- A. Carburetor Identification – V6 Outboards
- B. Carburetor Throttle Shutter Fit – V6 Outboards
- C. Front Cowl Latch Retorque – 1989 Model V6 Outboards
- D. Oil Injection Pump Identification – 3 Cyl. Models 70-75-80-90- and 4 Cyl. Models 100-115
- E. Driveshaft Bearing Race Installation – Model 35-40-50-60
- F. Test Lead Assembly P/N 91-814746 – V6 Outboard with EFI

Figure 1.

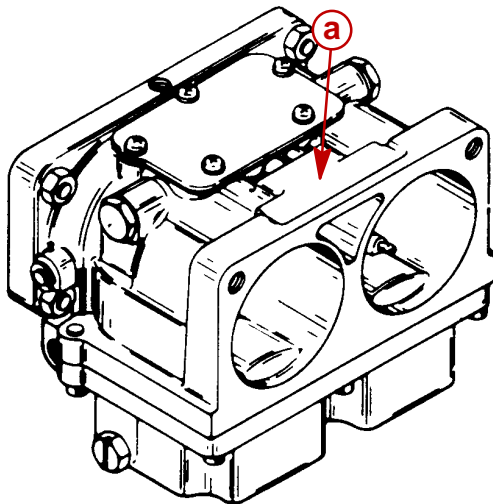
The carburetor identification number on V6 carburetors is no longer located on the carburetor mounting flange. The carburetor identification number is now located as shown in the following illustration. Figure 1.

Figure 3.

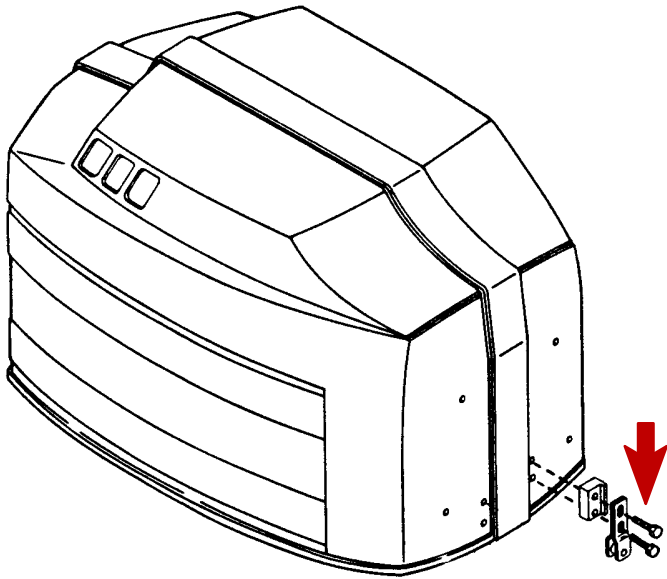
Mercury Marine has recently received reports of front cowl latches coming loose on 1989 V6 Outboards due to insufficient torque on the top cowl bracket screws. (Figure 3) It is recommended that all 1989 V6 Outboards, when being serviced for any reason, have the top cowl bracket screws (Figure 3) torqued to 180 – 210 lb. in.

Figure 4.

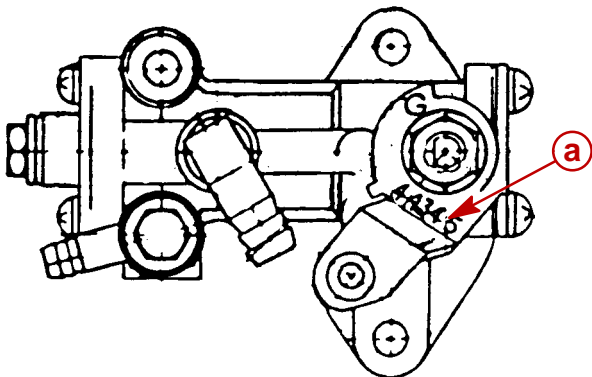
To identify the difference between the oil injection pump on the 3 cylinder and 4 cylinder outboards, the part number has been stamped on the lever as shown in Figure 4. P/N 42959 is stamped on the 3 cylinder oil injection pump lever and P/N 44345 on the 4 cylinder oil injection pump lever.

Figure 5. Installing Drive Shaft Bearing Race

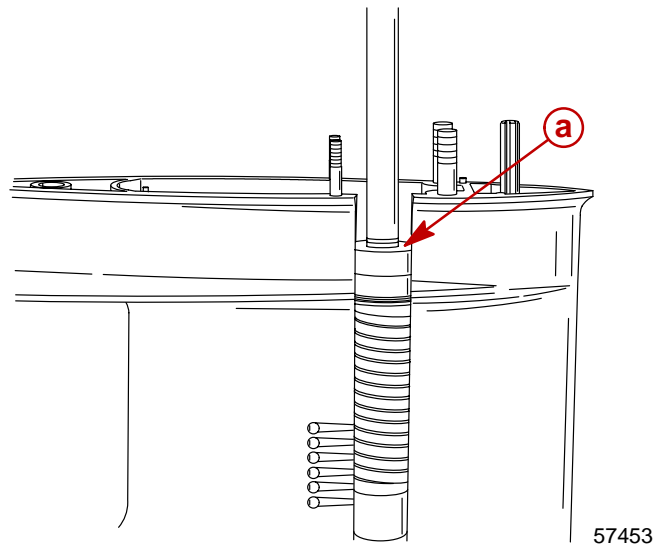
Outboard Service Manuals P/N 90-42794 884 and 9086135 1287 refer to the driveshaft bearing race installation tool as 91-38918. This is not the correct tool. The correct tool should be 91-86290. Figure 5.
